RFQ CCC-039 Instructional Building #1 - ADDENDUM 1

(FOR PRE-BID USE ONLY)
PRE-BID REQUEST FOR INFORMATION
COMPTON COMMUNITY COLLEGE DISTRICT
Send to ckober@pcm3.com ONLY!

Date of Pre-Bid RFI: <u>09/20/2018</u> Project Name: Instructional Building 1 Project No: CCC-039 Bid Package No.: N/A Bid Package Description: N/A	Bidder Name: GB Construction, Inc. _____ _____
---	--

A9.01
 75-15238-00

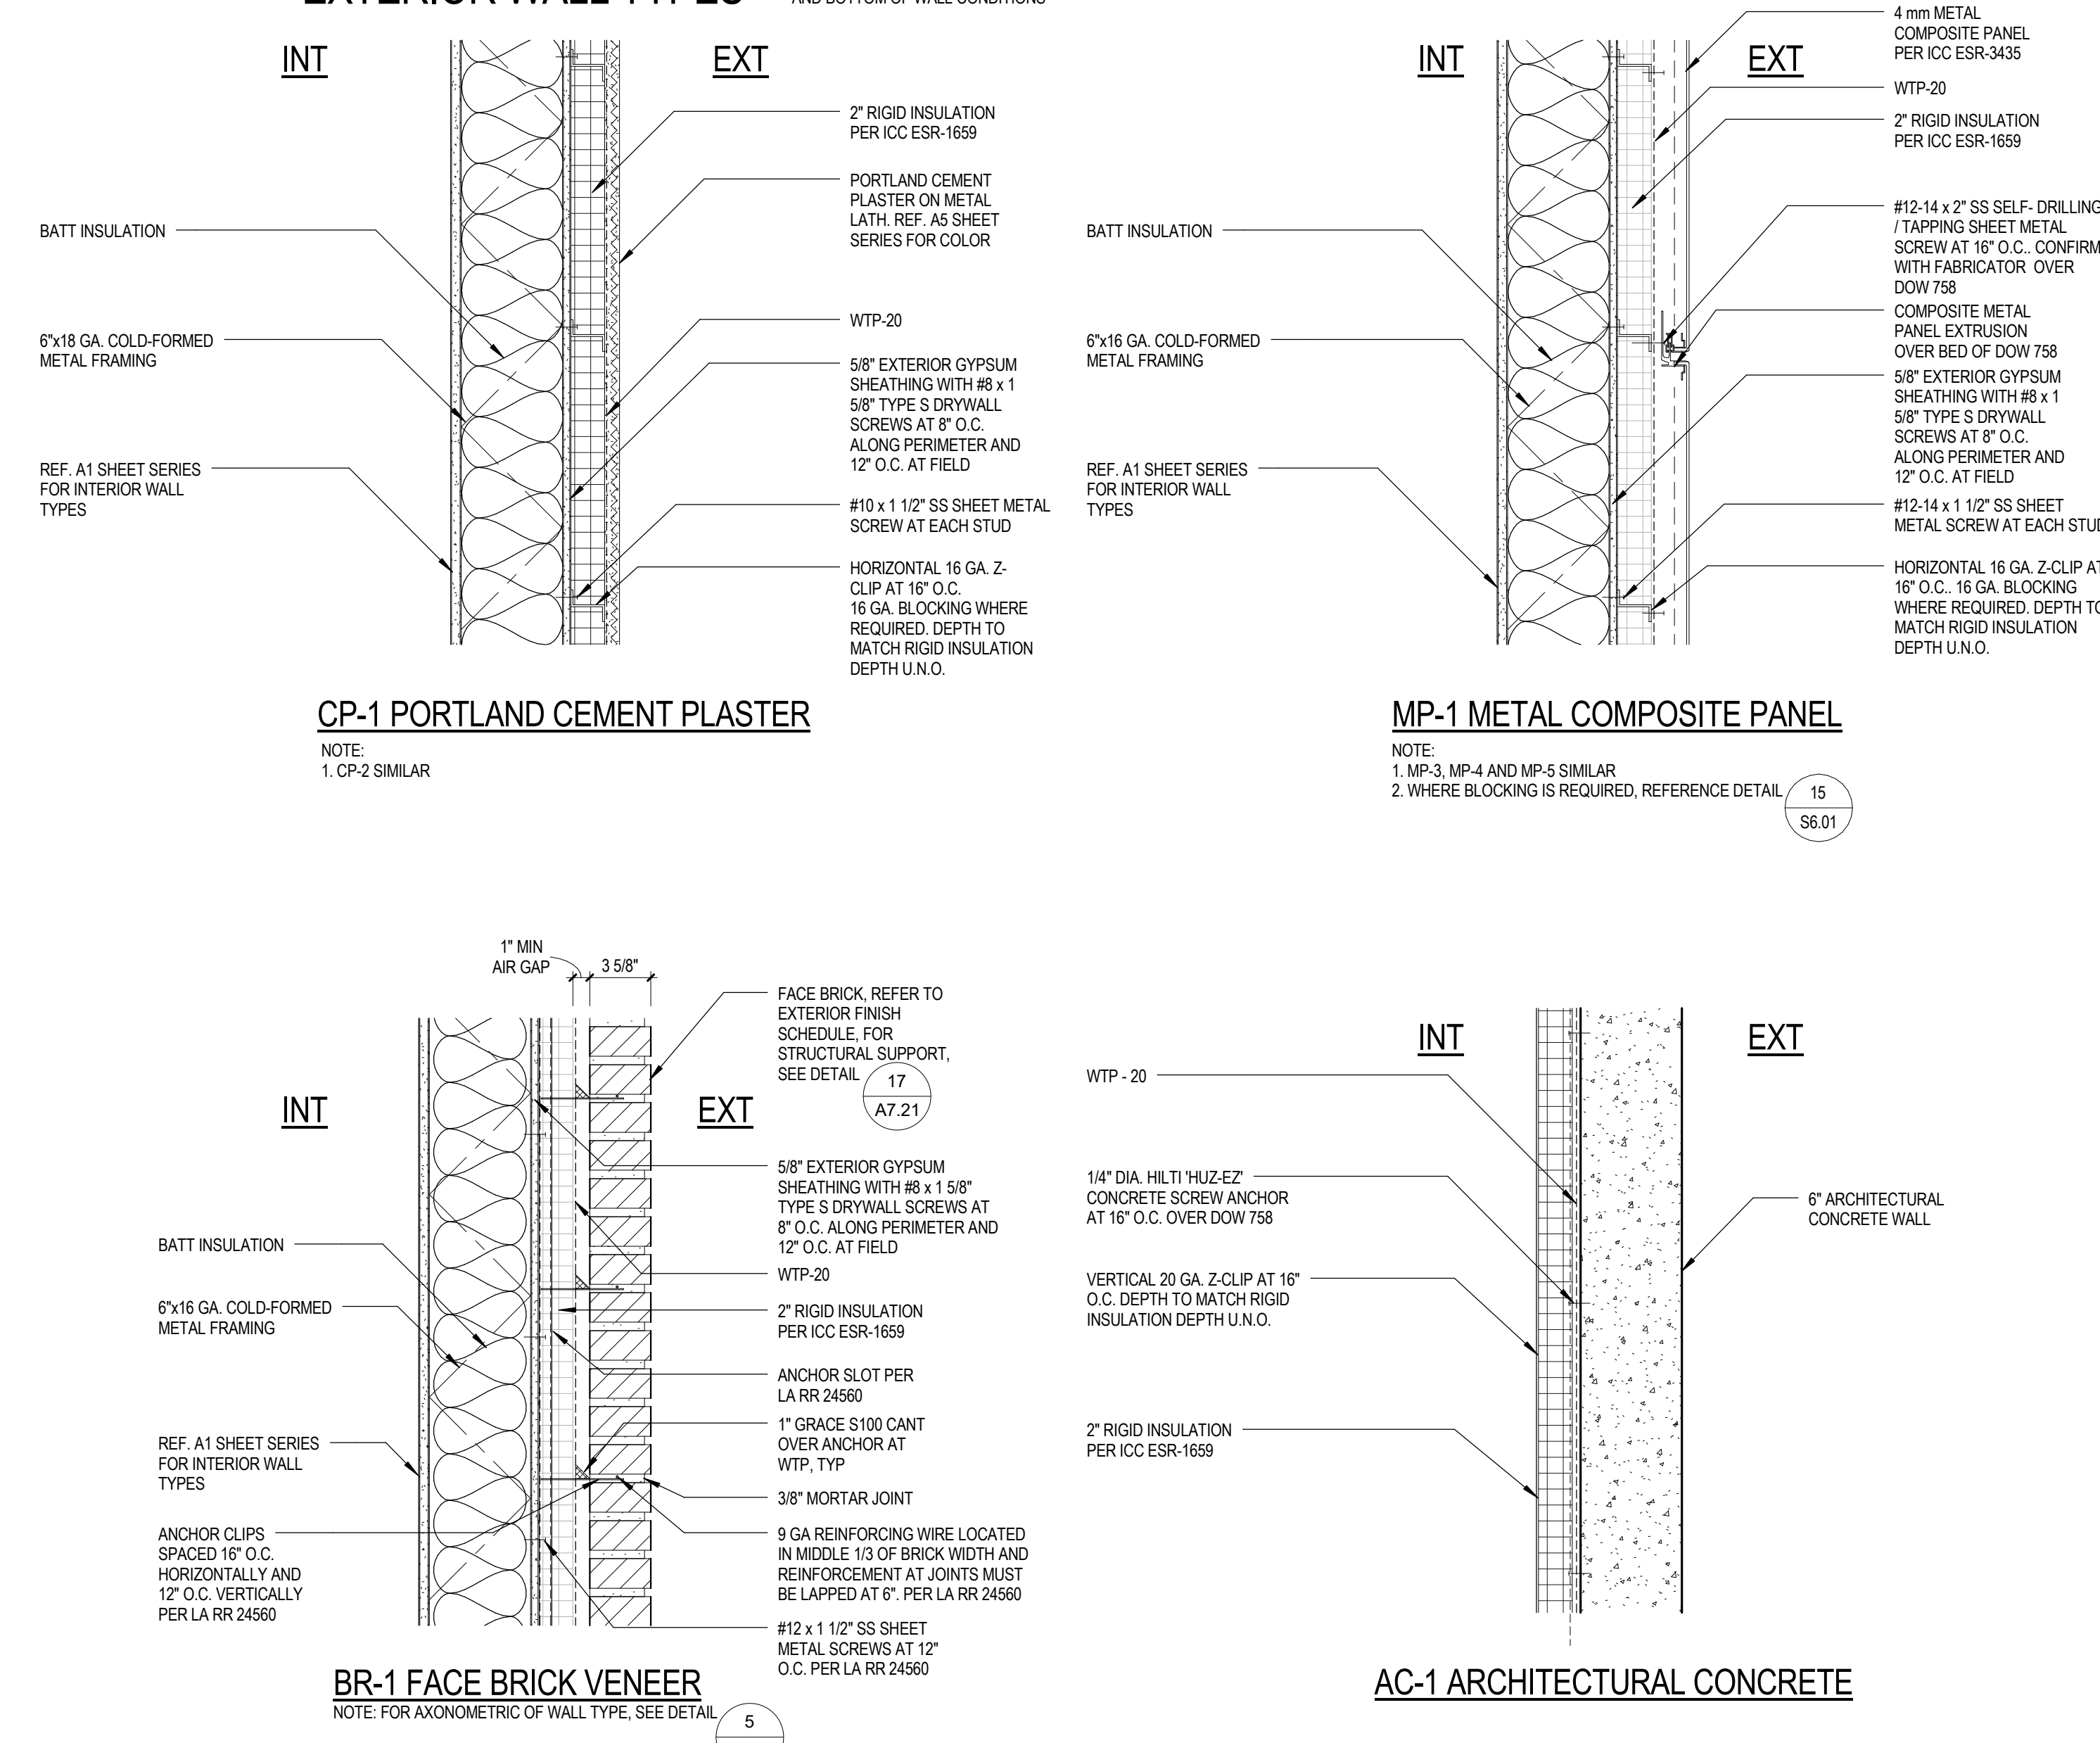
- C. Revised Keynote for S1, S2, and S3 Interior Wall Types: Added "Substitute 5/8" Densglass Board Substrate where tile occurs"
- D. Revised Details 7 and 11 showing cove trim at corner per 4/A10.06.
- E. Added Detail 3/A9.01 – TILE, SINGLE SIDED: Showing conditions in restroom wall furring.
